NOTICE OF REGULAR MEETING ASHLAND PLANNING COMMISSION

ICEHOUSE RIDGE
PRELIMINARY PLAT AND PLANNED UNIT DEVELOPMENT

Ashland Planning Commission & City Council
c/o Bill Krejci, Ashland Building & Zoning Official
2304 Silver Street
Ashland, NE 68003

JEO Consulting Group has received a copy of the preliminary plat documents for the above referenced subdivision. We have reviewed these documents and would offer the following comments, questions, and observations for the Planning Commission's scheduled meeting on March 25, 2021.

BLUE JAY WAY - PAVING PLAN AND PROFILE
SCALE: HORIZONTAL 1"=100'
VERTICAL 1"=10'

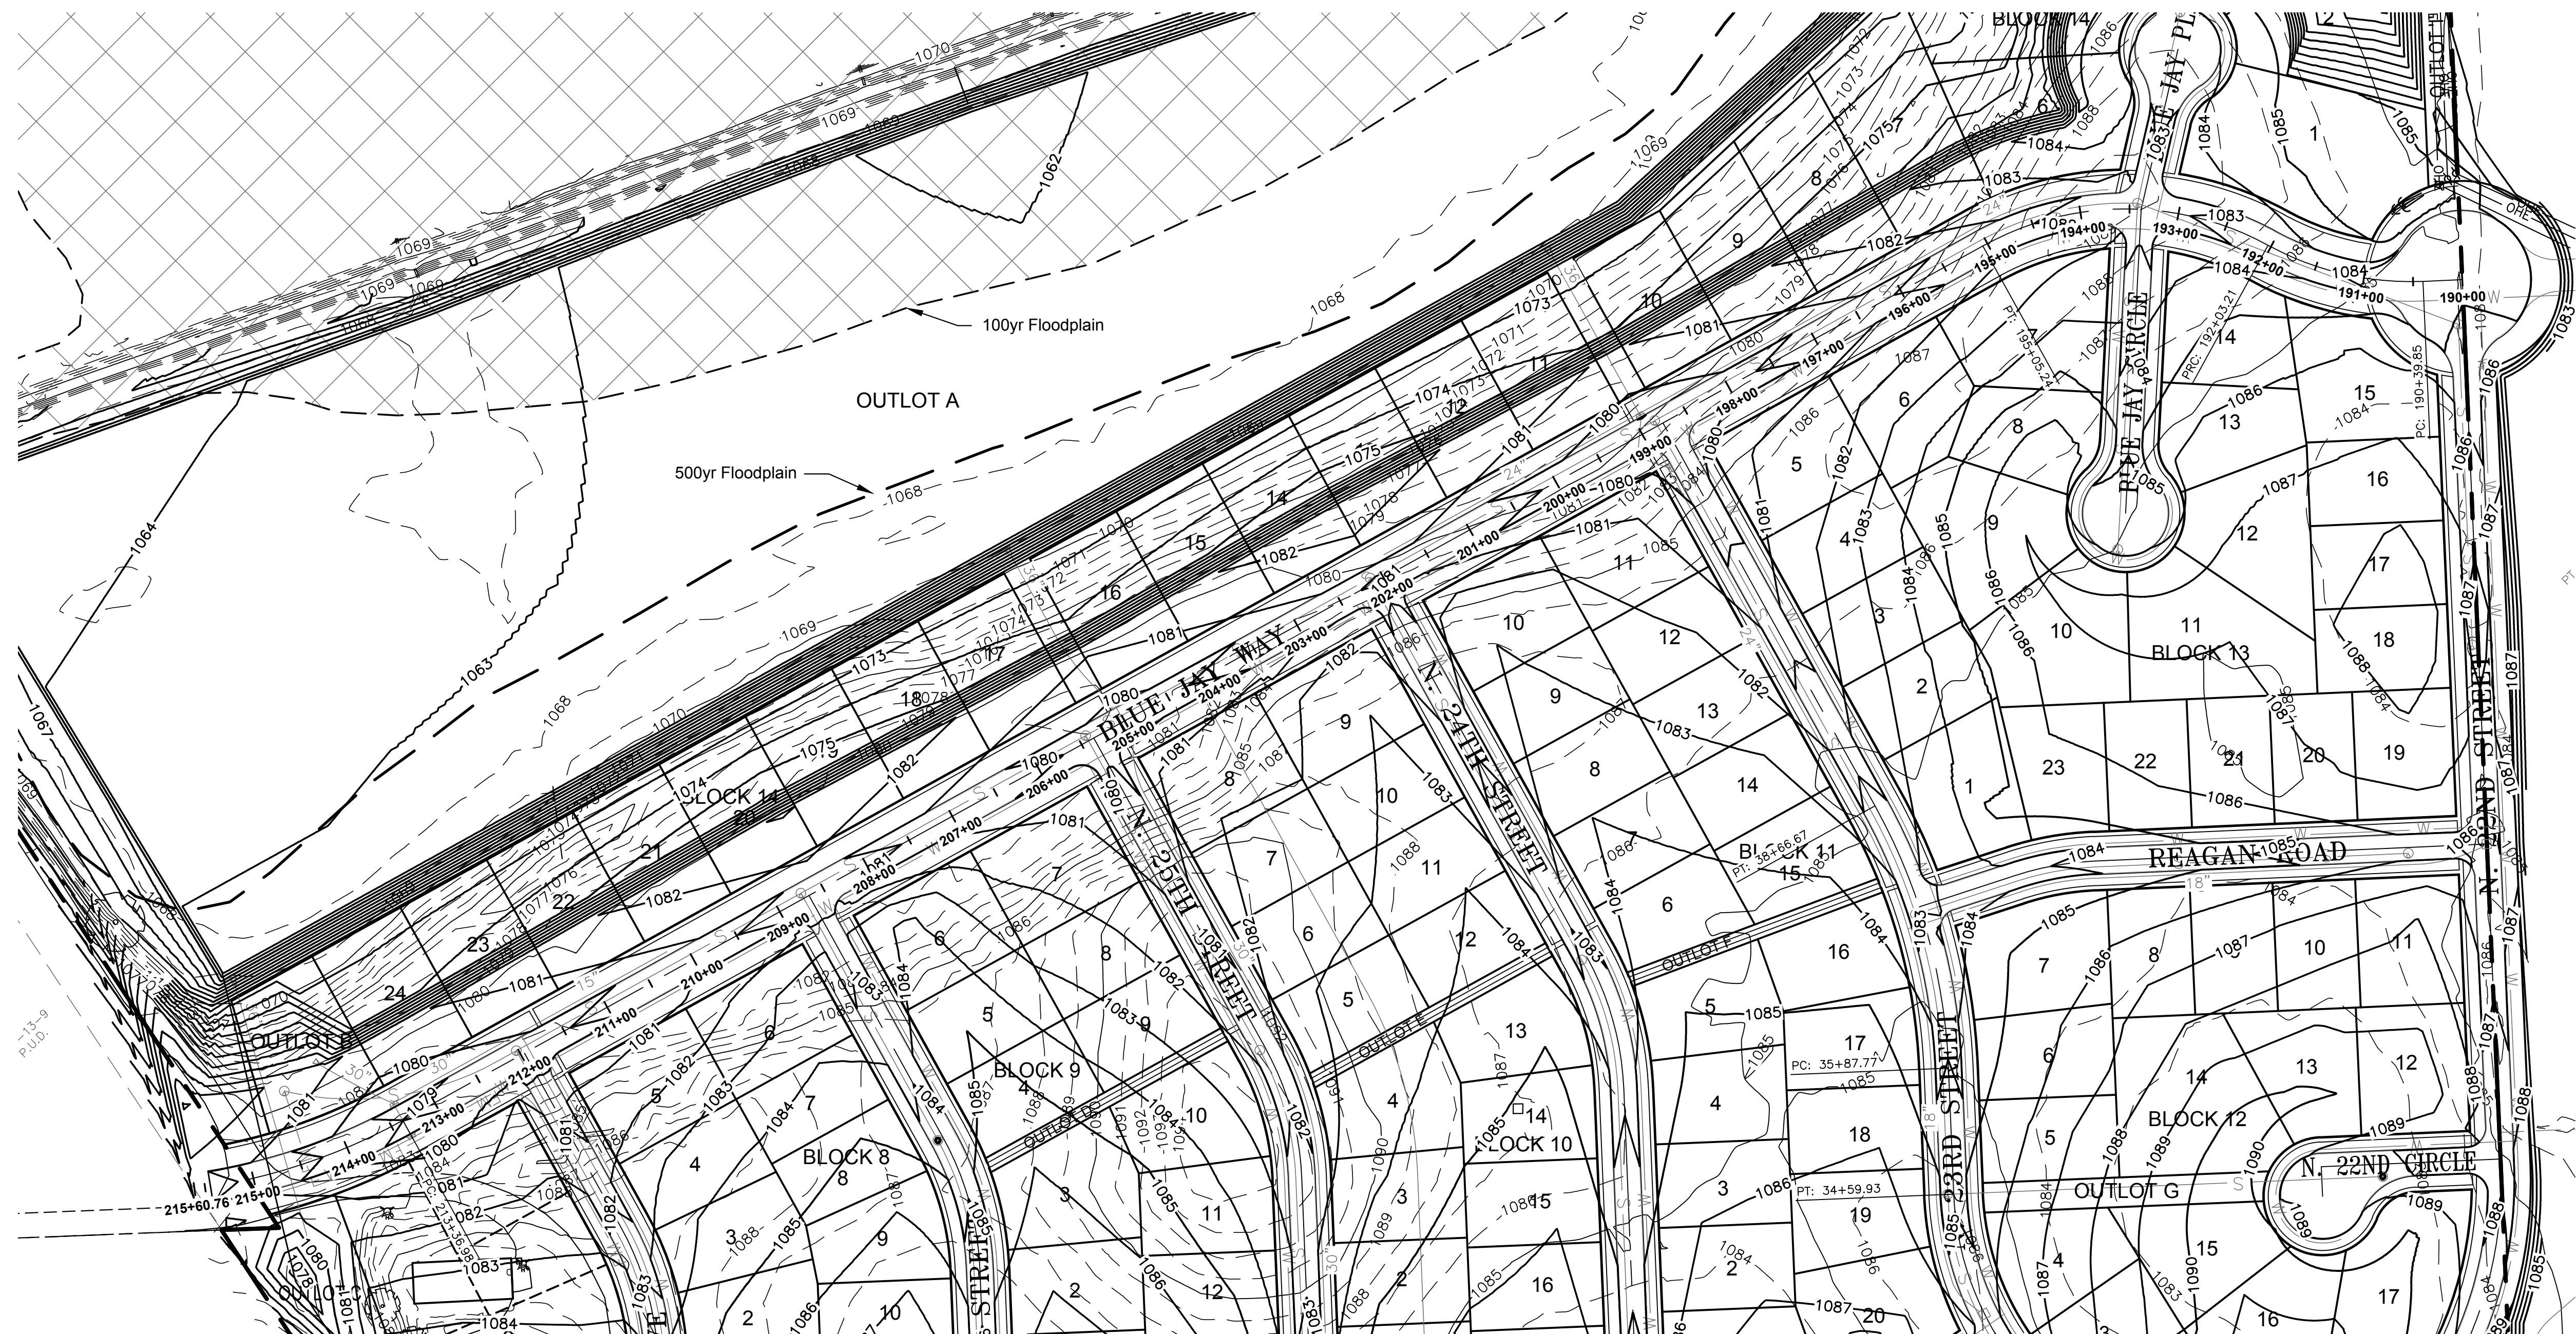
- THE OWNER/DEVELOPER RESERVES THE RIGHT TO BUILD ANYWHERE WITHIN THE SETBACKS AS PER THE ZONING DISTRICT OR AS MODIFIED BY WAIVERS.
- STREET PAVEMENT WIDTH FOR BLUE JAY WAY SHALL BE THIRTY-TWO (32) FEET WIDE AND PAVEMENT THICKNESS SHALL BE EIGHT (8) INCHES THICK.
